DEPARTMENT OF ENERGY**Federal Energy Regulatory Commission****18 CFR Part 40**

[Docket Nos. RM12-6-000 and RM12-7-000]

Revisions to Electric Reliability Organization Definition of Bulk Electric System and Rules of Procedure**AGENCY:** Federal Energy Regulatory Commission, DOE.**ACTION:** Notice of proposed rulemaking.

Figure 1

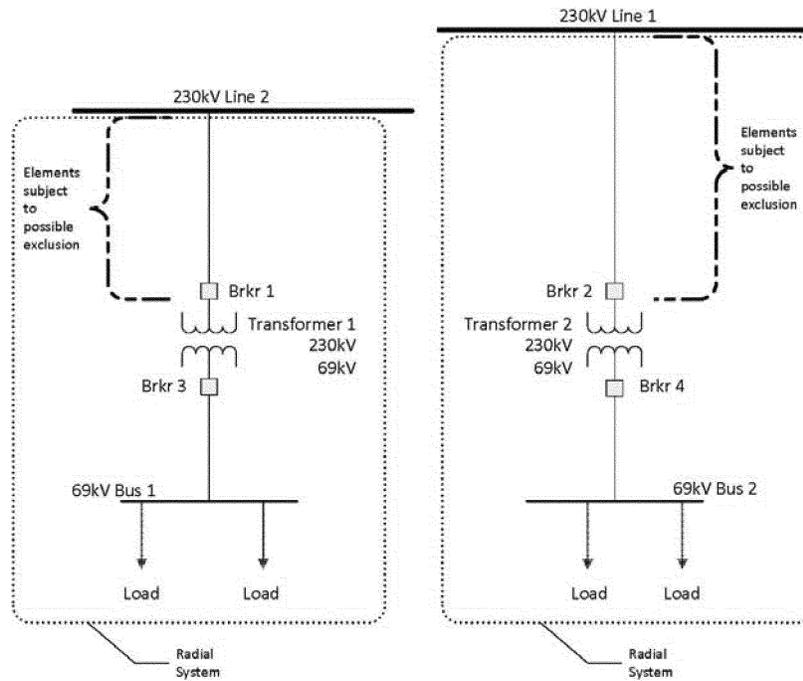
79. Figure 1 below depicts facilities configurations in which all of the 230 kV and 69 kV transmission elements emanate from a single point of connection of 100 kV or higher. The Commission seeks comment on whether each of the radial systems shown in figure 1, the 230 kV elements above each transformer to the point of connection to each 230 kV line, respectively, are excluded from the bulk electric system pursuant to exclusion E1.

Figure 2

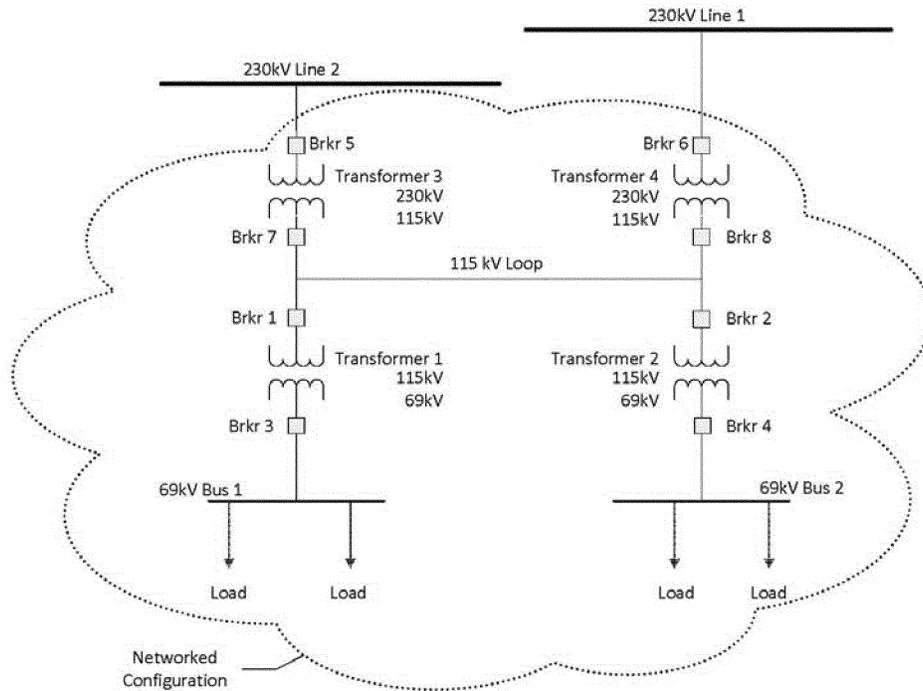
80. Another scenario shown in figure 2 below depicts a configuration containing a 115 kV loop, with the configuration emanating from two points of connection of 100 kV or higher. We seek comment whether, in

shown in figure 2 more appropriately analyzed pursuant to the "local network" exclusion E3 and, if so, what if any elements operated at or above 100 kV would be excluded pursuant to exclusion E3?

Figure 3

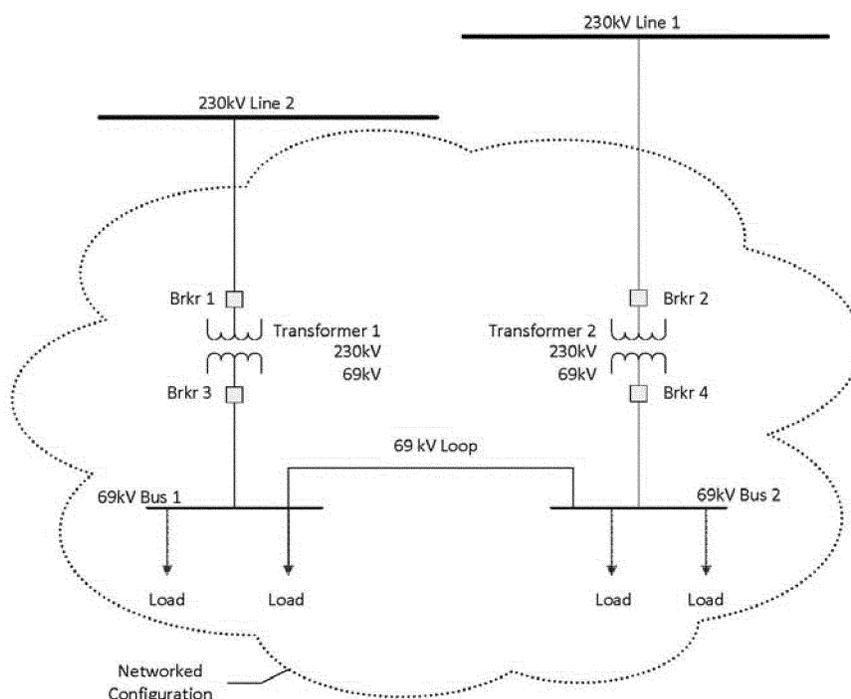
configuration remains contiguous through elements that are operated below 100 kV. For example, figure 3 below depicts a configuration with two points of connection of 100 kV or higher that are contiguous through a 69 kV loop. We seek comment on how to evaluate the configuration in figure 3 vis-à-vis the radial system definition and whether it is appropriate to examine the elements below 100 kV to

determine if the configuration meets the exclusion E1 definition for radial systems. In other words, does figure 3 depict a system emanating from two points of connection at 230 kV and, therefore, the 230 kV elements above the transformers to the points of connection to the two 230 kV lines would not be eligible for the exclusion E1 notwithstanding the connection below 100 kV?

Figure 4
69 kV Networked Configuration with Normally Open Switch

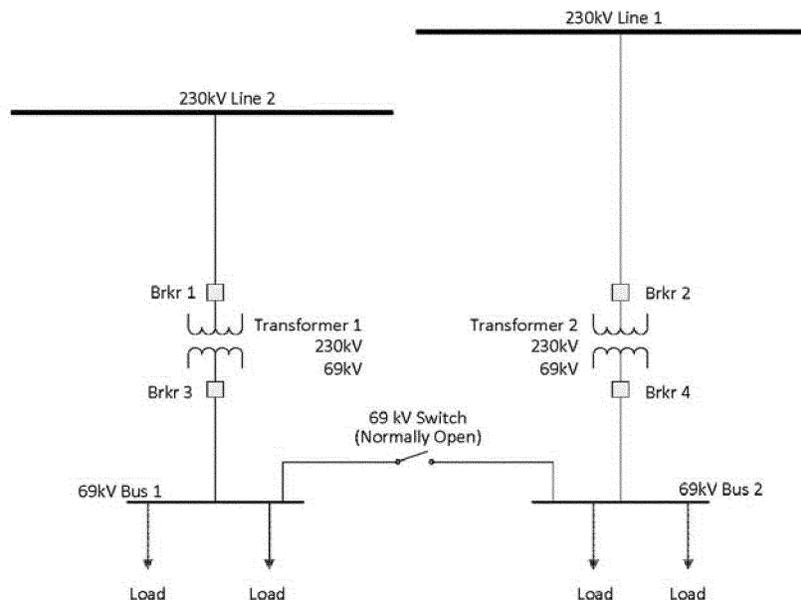
86. Figure 4 below illustrates a configuration with a normally open switch.

87. NERC states that “a normally open switch” will be identified in documents such as prints or one-line diagrams and that “[t]he concept and usage of the ‘normally open switch’ in such configuration is well understood in the electric utility industry.”¹⁰⁵ We seek comment on NERC’s characterization and whether the phrase “normally open” is subject to interpretation or misunderstanding, or whether a “normally open” configuration is potentially difficult to oversee. Further, we seek comment on the need of transmission operators or other functional entities to study the system impacts of the closing of a “normally open” switch, or to take other steps to ensure awareness of the impacts of the loop that is created by the closing of the

Figure 5

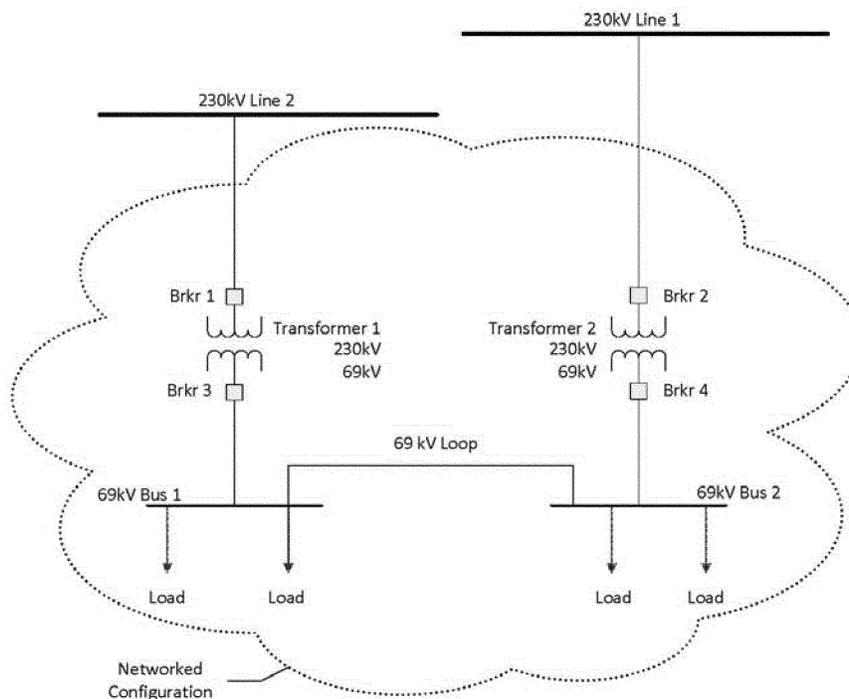
95. As stated above, exclusion E3 defines local networks as “[a] group of contiguous transmission Elements operated at or above 100 kV but less than 300 kV that distribute power to Load rather than transfer bulk-power across the interconnected system.” While the local network exclusion applies to contiguous transmission elements operating at a minimum of 100 kV, it is unclear how the exclusion applies to a looped lower voltage system. For example, figure 5 depicts a 69 kV looped system emanating from two points of connection at 100 kV or higher.

The configuration in figure 5 depicts a group of elements that are contiguous through a 69 kV loop. We seek comment whether the configuration in figure 5
